# DOVER PLANNING BOARD – AGENDA

| Meeting Date: | **Tuesday, March 10, 2026** |

B. Consideration and acceptance of a Site Review for 5 Sherman Street, LLC, Assessor's Map 19, Lot 8, zoned R-12, located at 103 Court Street. (Proposal is to maintain an existing single-family dwelling and construct four (4) new single-family homes for a total of five (5) dwelling units with two (2) of the new single-family homes size-restricted to 1,400 square feet each.) *(SITE-2024-0012) (*This item was continued from the January 27, 2026 Planning Board meeting.)**

## S-1 SEWER NOTES:

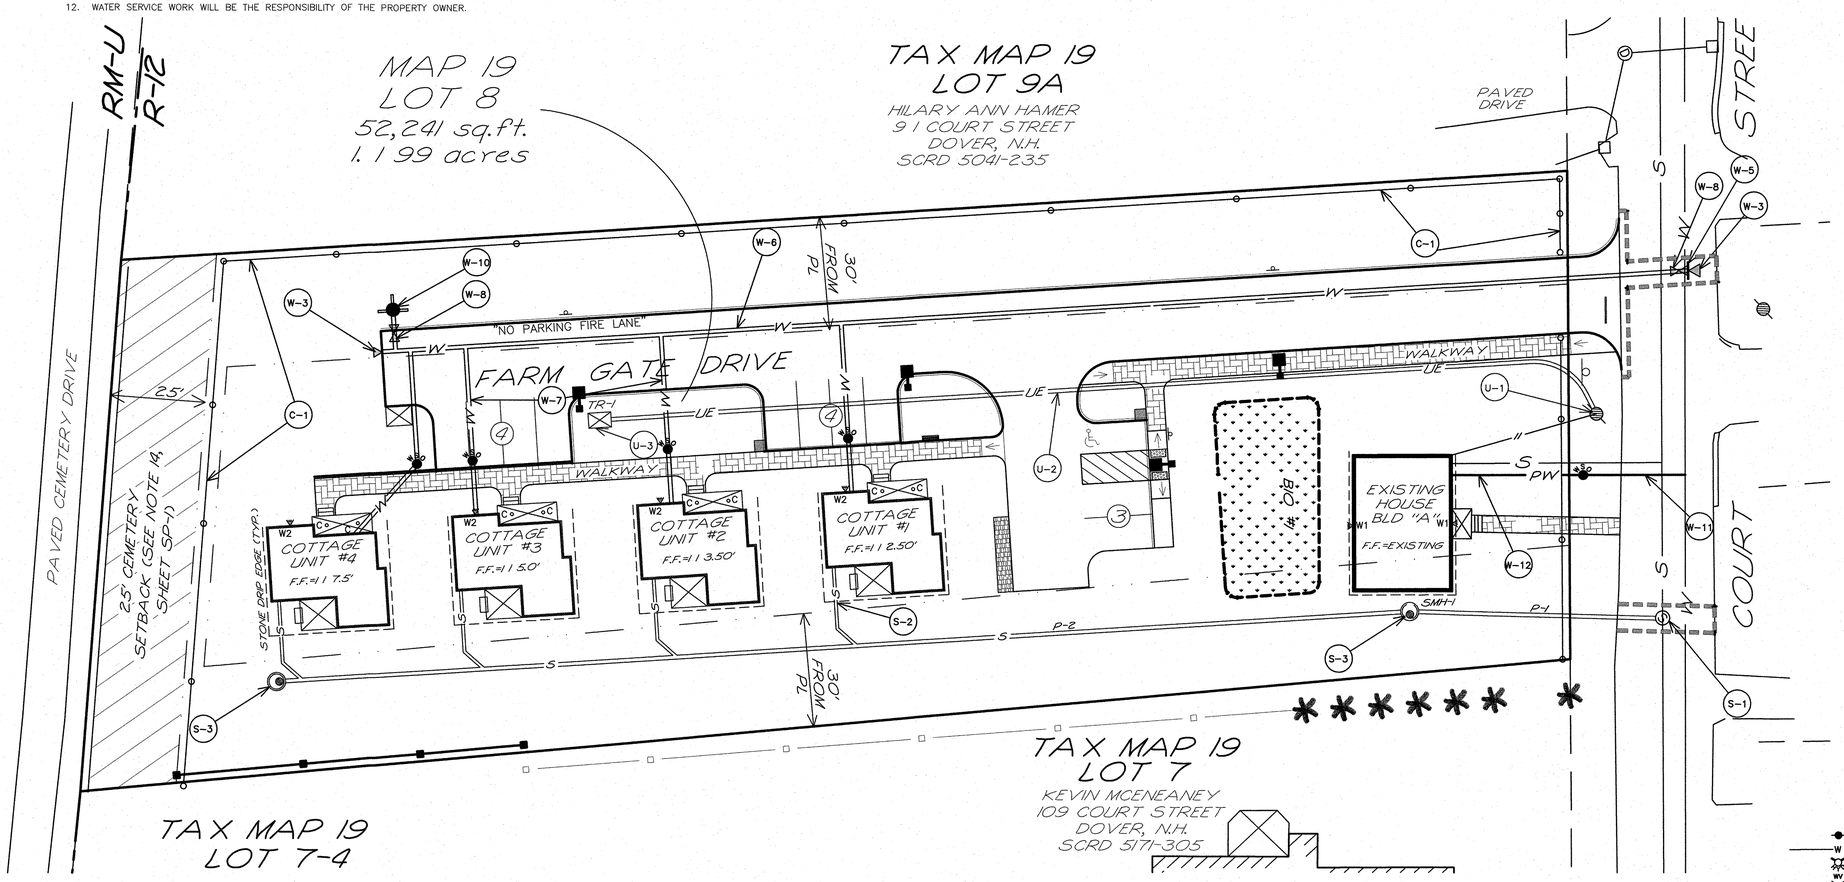
***Note S-1 on Sheet Sp-3 references core and boot for the new invert.***

***Note S-1 on Sheet Sp-3 references the invert to be rebuilt and the drop does not drop onto the shelf.***

*Note S-1 on Sheet Sp-3 references core and boot for the new invert.*

***Note S-1 on Sheet Sp-3 references the invert to be rebuilt and the drop does not drop onto the shelf.***

1 BIO-RETENTION #1 CROSS SECTION WITH OUTLET STRUCTURE
NOT TO SCALE

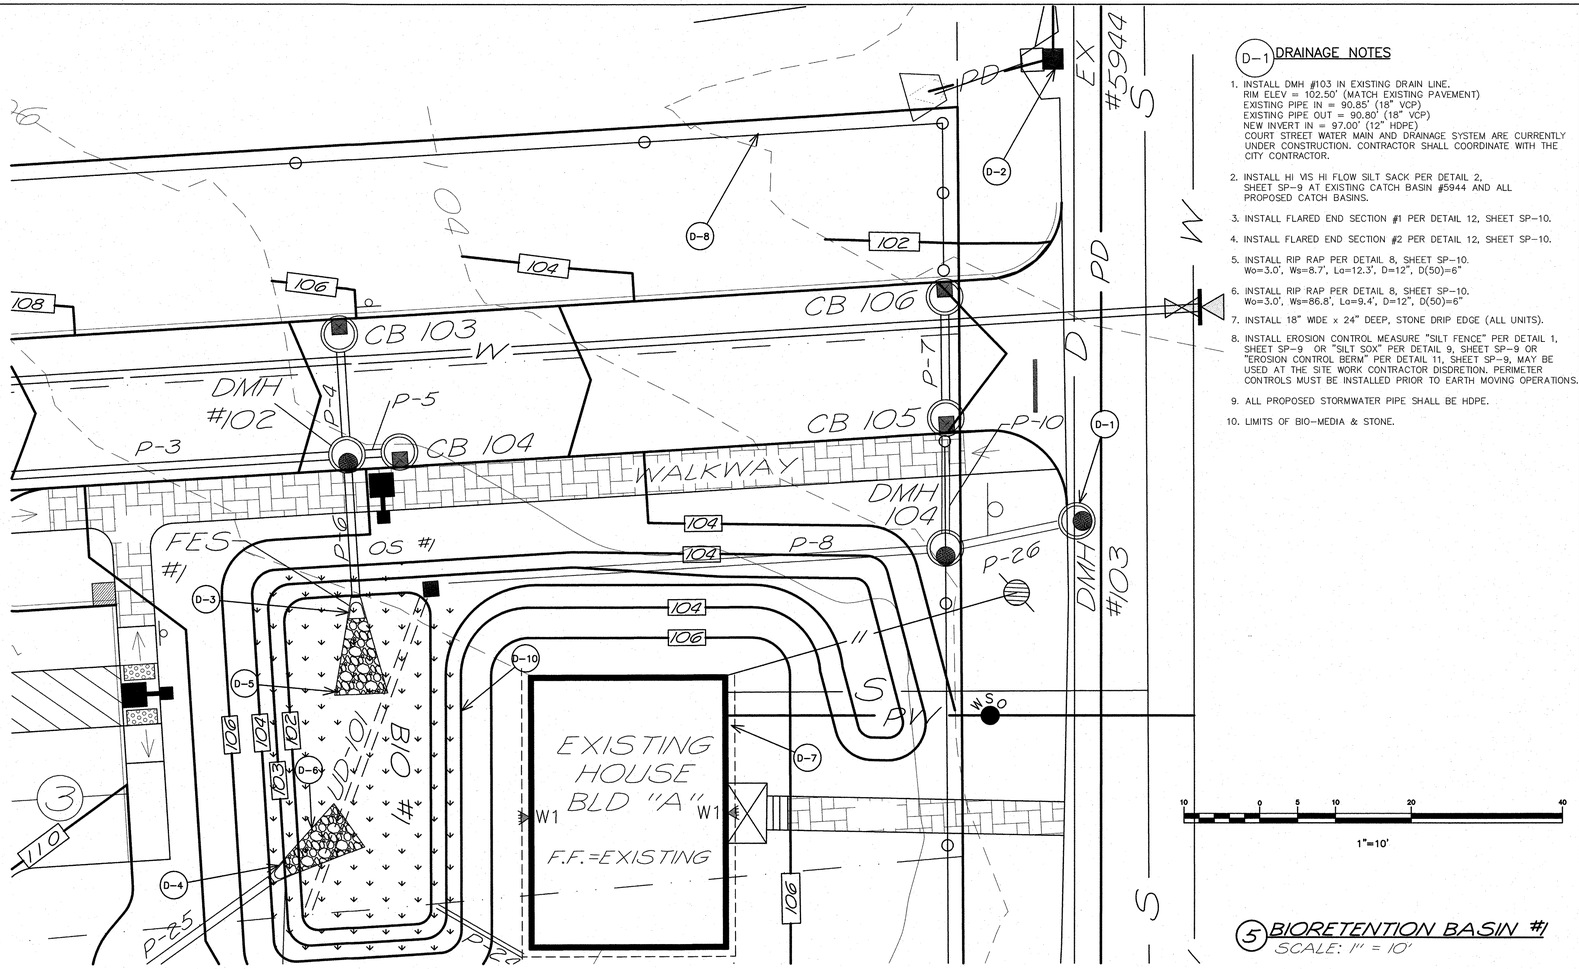
section. P-10 is also not shown in the cross section. Confirm structure naming; Bio #1, Bio #101, and OS#1.
- Applicant to update City standard details with latest.
- SP-10 Detail 10 missing material type and reinforcing details.
- SP-11 Internal Drop detail to show core and boot at inlet pipe
- SP-11 manhole invert must be rebuilt. Drop shall not drop onto shelf.
- Missing yard drain detail.
- TDR Narrative should be revised to account for 5 single family units being proposed. Narrative discusses adding a barn and addition of 9 units, 4 of which would be designated affordable housing, which may no longer be the case.
- Water and Sewer demand shows duplex and prior design.
- Stormwater analysis – proposed analysis has not been updated for the revised site plan layout.

***The Bioretention cross-section on sheet SP-5 has been revised to be consistent with plan view. P-10 has been added to the profile on Sheet C-1. Structure names have been revised to match.***
